Responses to AIR Data Requests – Nos. 12 through 42

Amended Application for Certification for HYDROGEN ENERGY CALIFORNIA (08-AFC-8A) Kern County, California

**RESPONSES TO DATA REQUESTS 12 THROUGH 42
FROM THE ASSOCIATION OF IRRITATED RESIDENTS (AIR)**

Source: Aerial Imagery, Bing Maps, 2009; Existing Land Use: Kern County, 2011

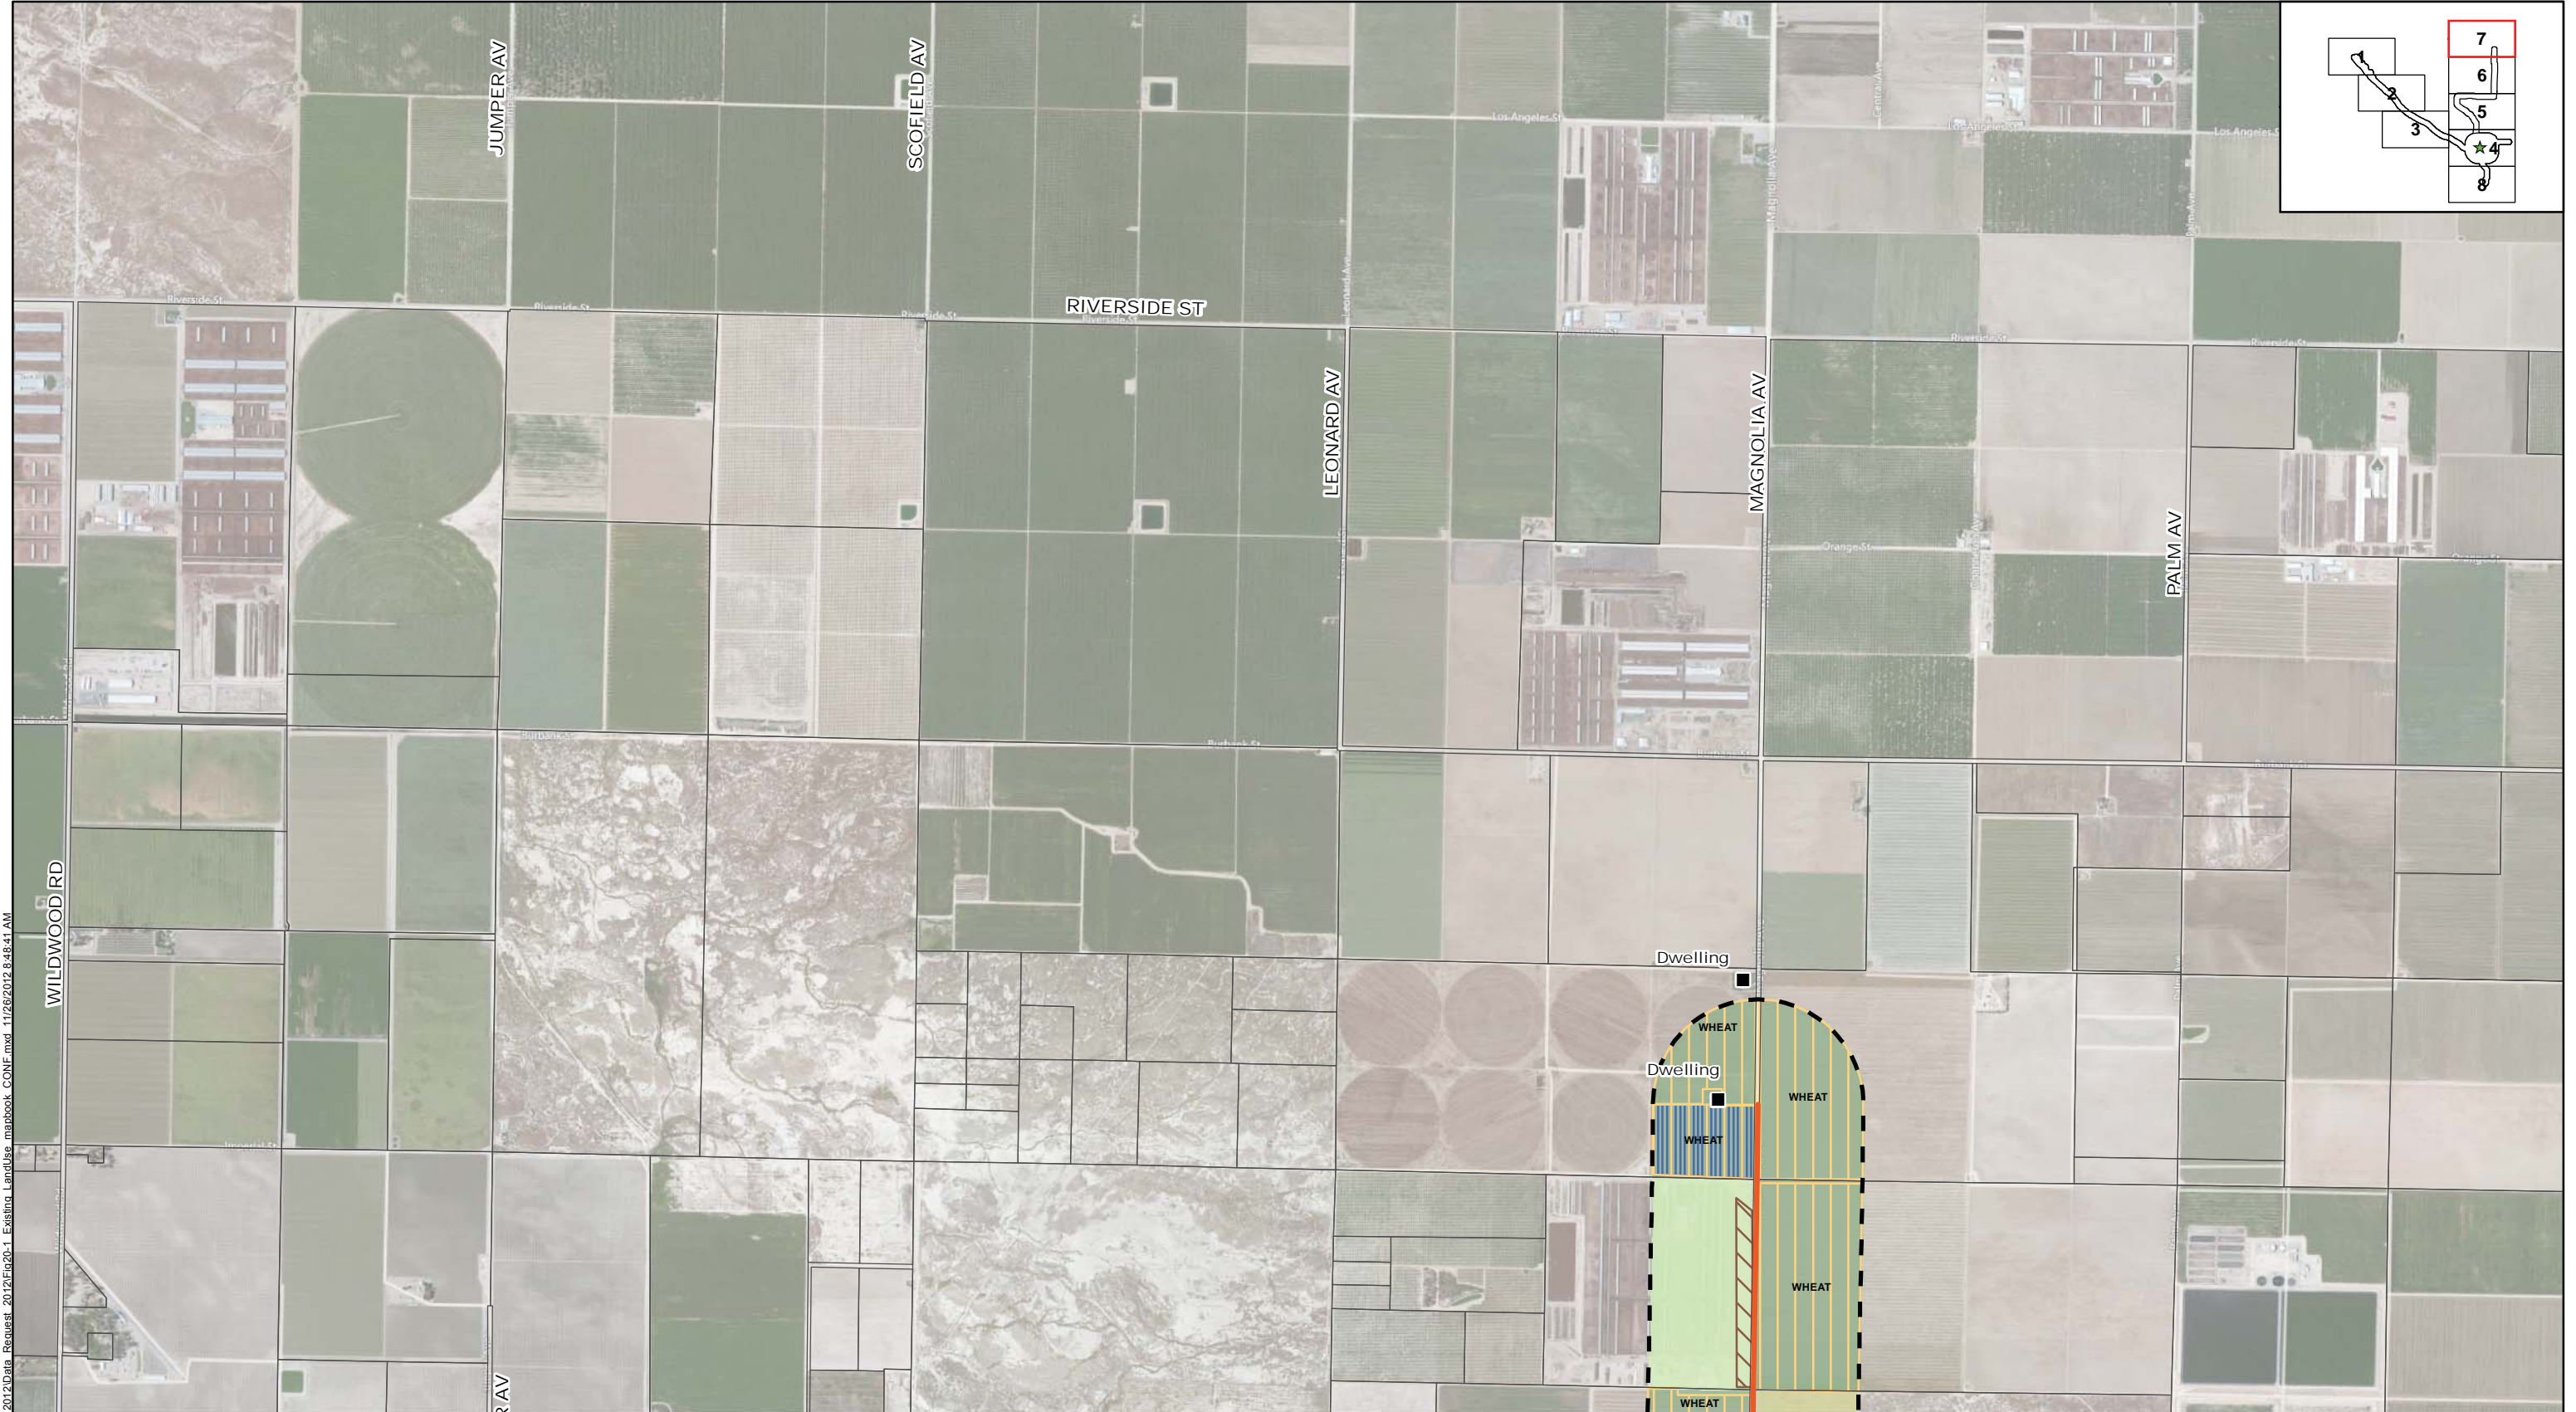
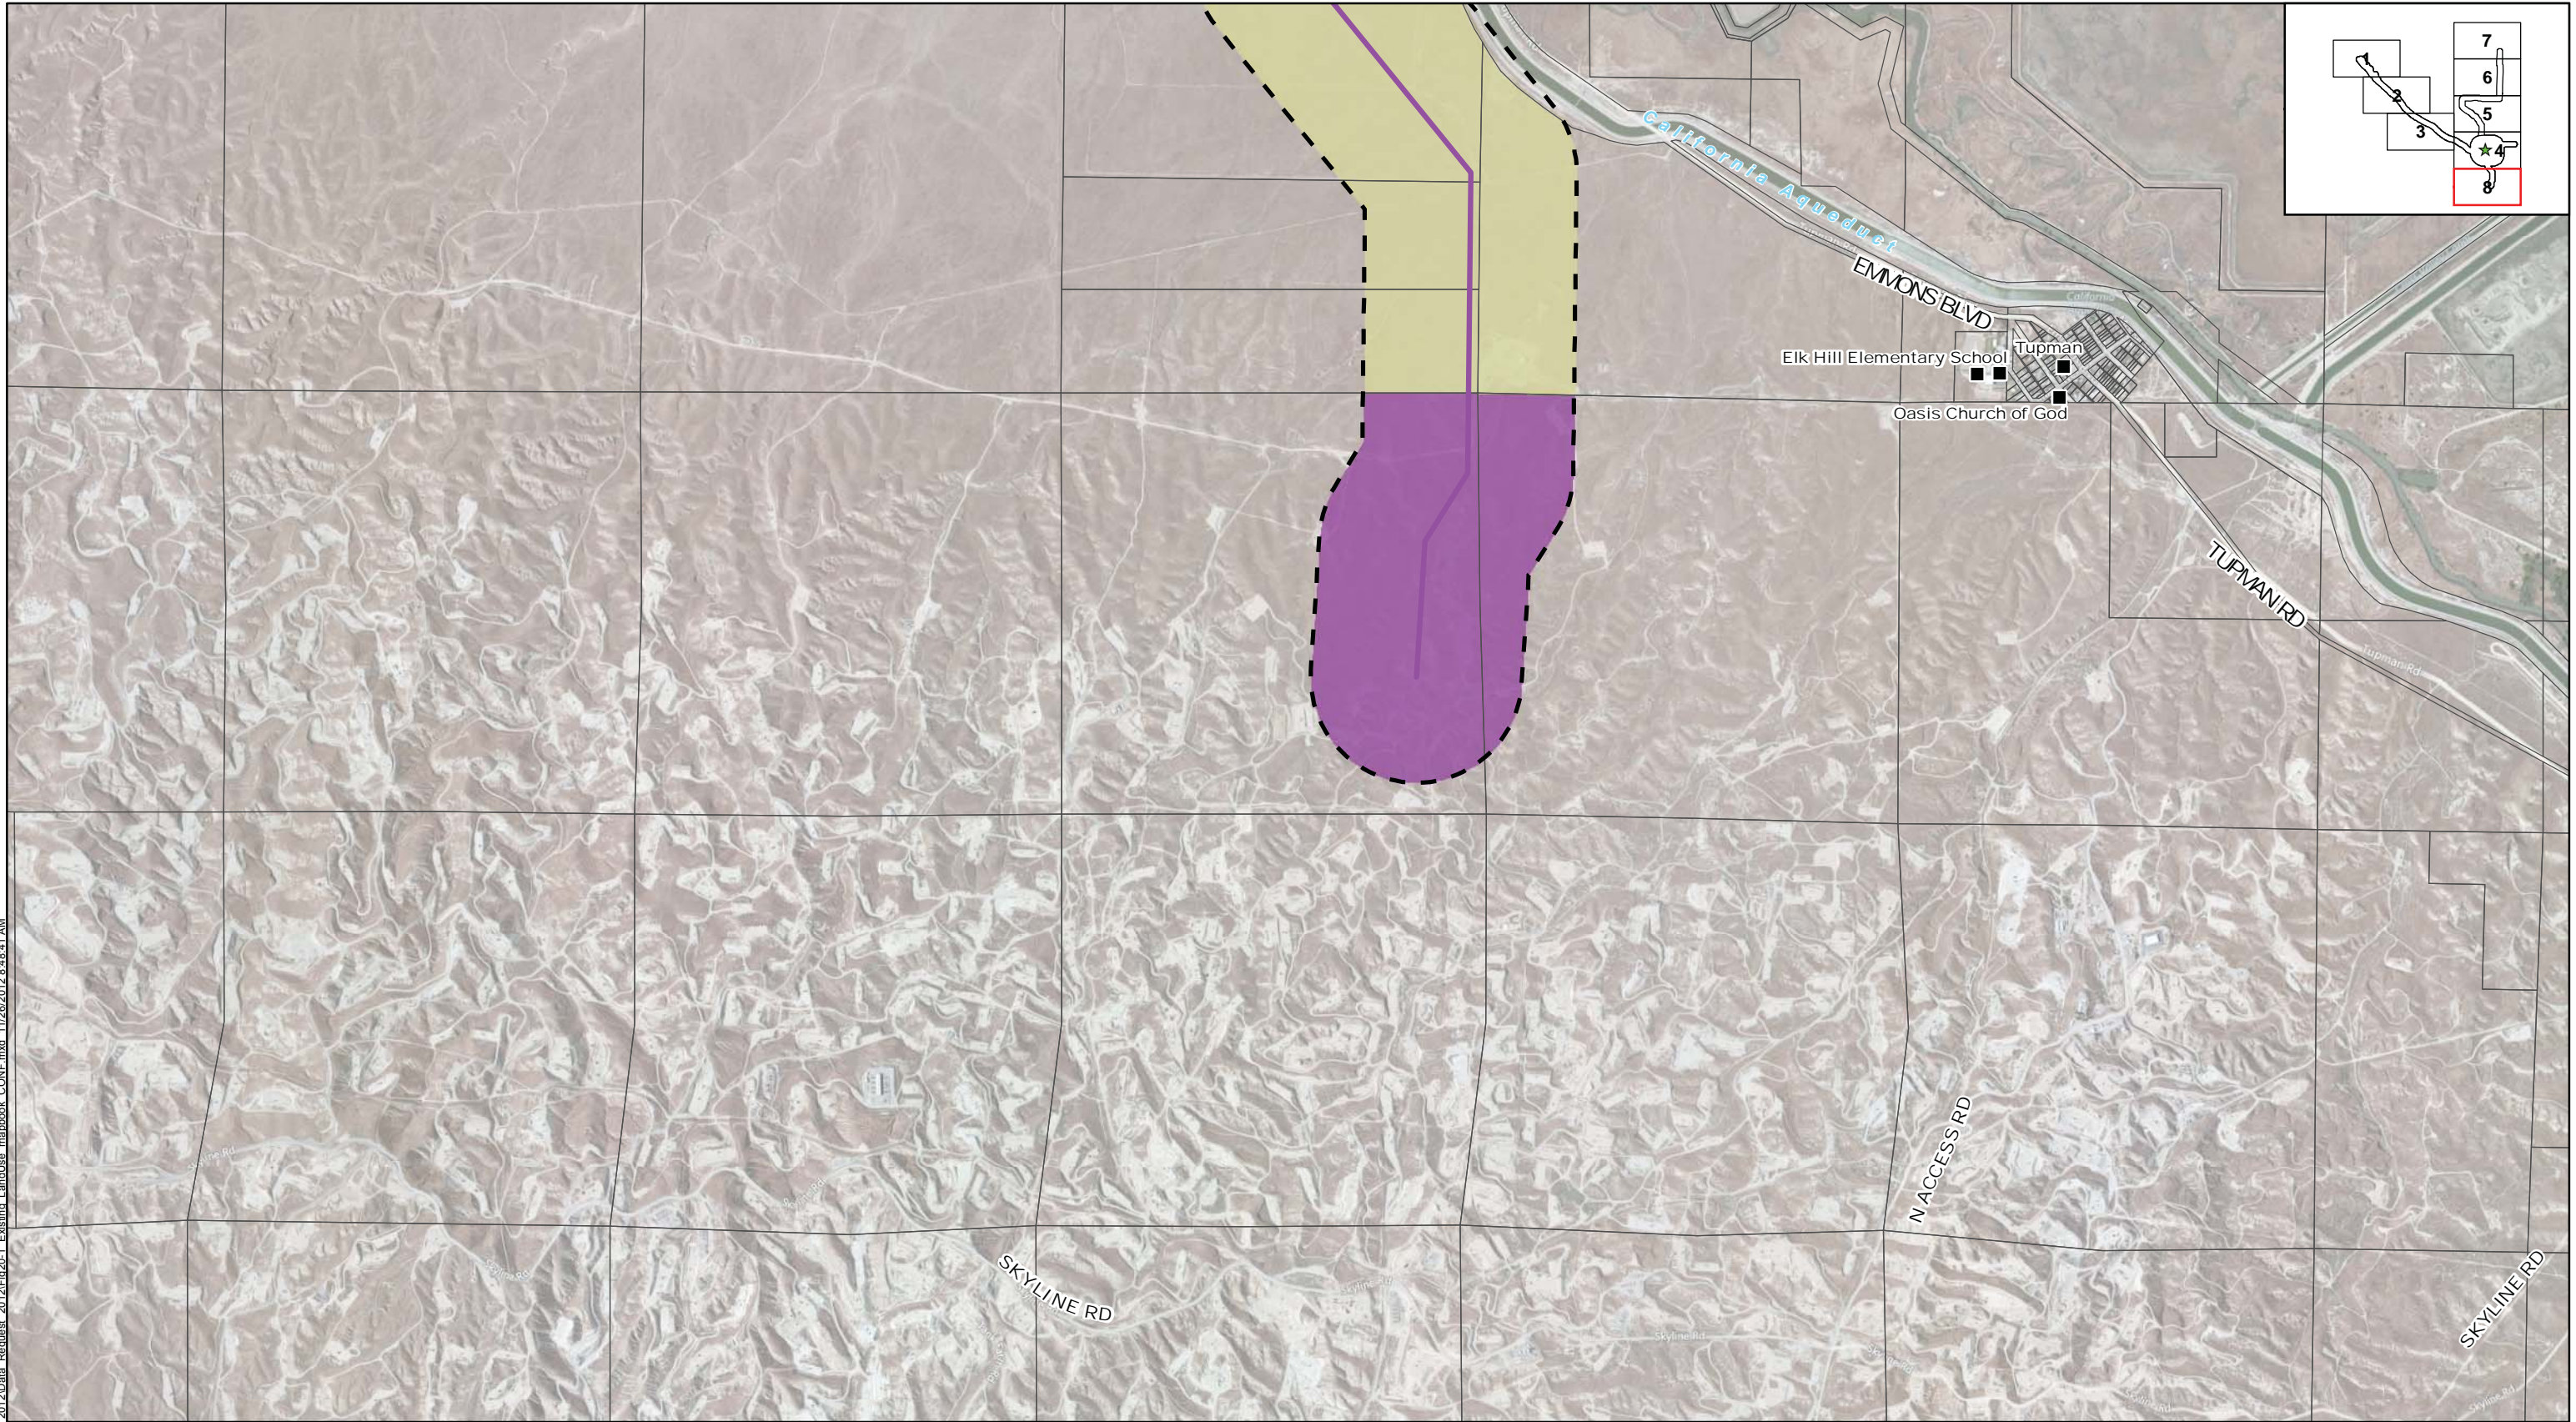
- (2) Where will the railroad spur be located? Please provide a map with details of the exact right of way needed so that each affected land owner will know exactly what is proposed on their respective properties.**

2. Figures showing the location of the railroad spur were previously provided to the CEC under confidential cover in May 2012. For reference and since the route is no longer confidential, the figures showing the location of the railroad spur and the land uses along the route are attached to this document as Figures 20-1 Sheets 1 through 8.
3. As indicated in the response to AIR Data Requests 1 and 2, as a private entity, HECA does not have the power of eminent domain. Thus, there are no plans to acquire any property or rights of way needed for the Project by eminent domain.
4. The exact route staff will travel to the Site will depend upon their point of origin but in general staff will travel from Stockdale Highway to Dairy Road and into the plant via the entrance off of Dairy Road. Alternatively, staff will travel via the truck route described in the response to Data Request 24 (3).
